1CAN010603

SUBJECT: Supplement to Amendment Request
Revision of the Allowable Value for Emergency Feedwater Initiation and Control
Function (EFIC)
Arkansas Nuclear One - Unit 1
Docket No. 50-313
License No. DPR-51

Response to Request for Additional Information Related to Revision of the Allowable Value for Emergency Feedwater Initiation and Control Function (EFIC)

Figure 1

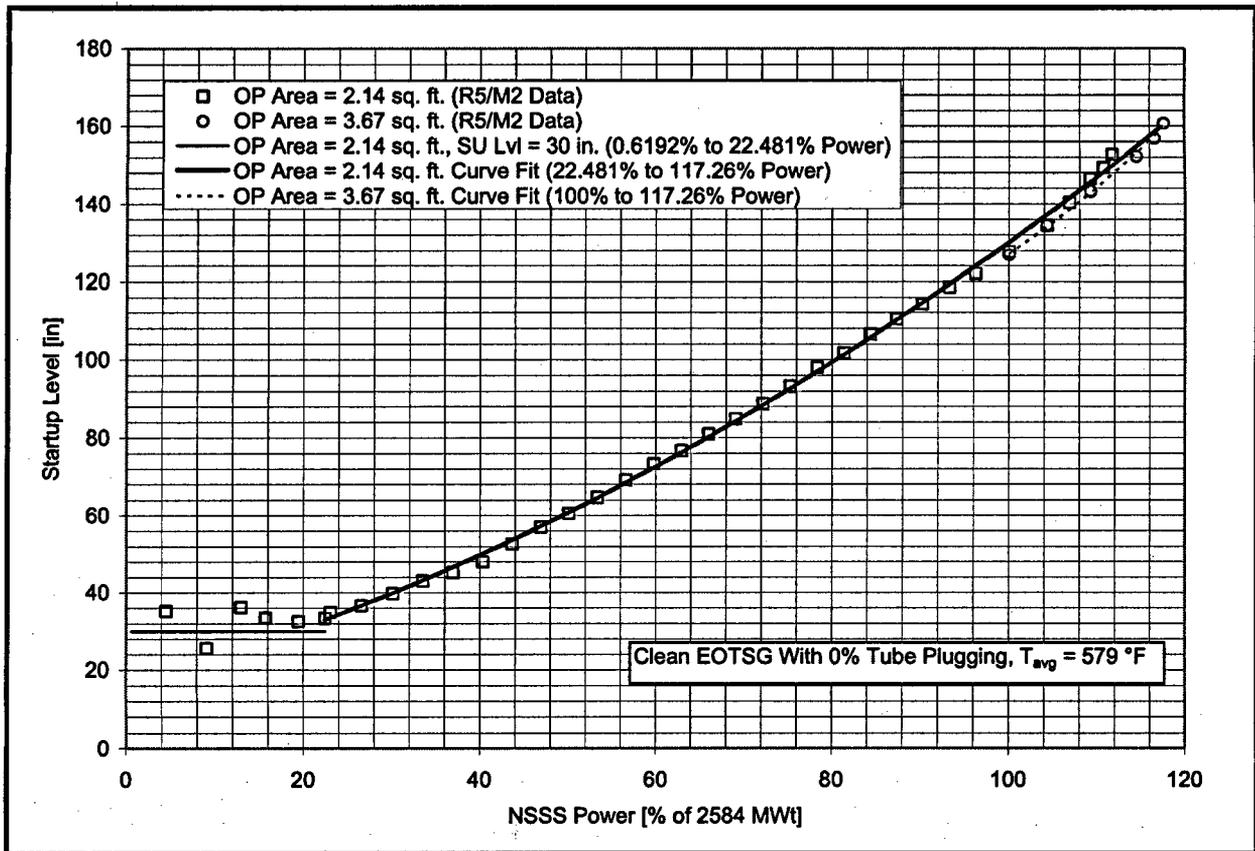
Please provide more detail on comparative analysis that was done to address this concern during the pre-operational phase of design/engr./installation. Documented descriptions of analyses and results would be appreciated.

The RELAP5 thermal hydraulic computer code was used to model the OTSG and EOTSG. OTSG plant startup and operate range level data was used to benchmark the OTSG model and the EOTSG changes were incorporated into the OTSG to form the EOTSG predictions, as shown in Figures 1 and 2. Data from the EOTSG at 98% power agree well with these predictions for startup and operate range.
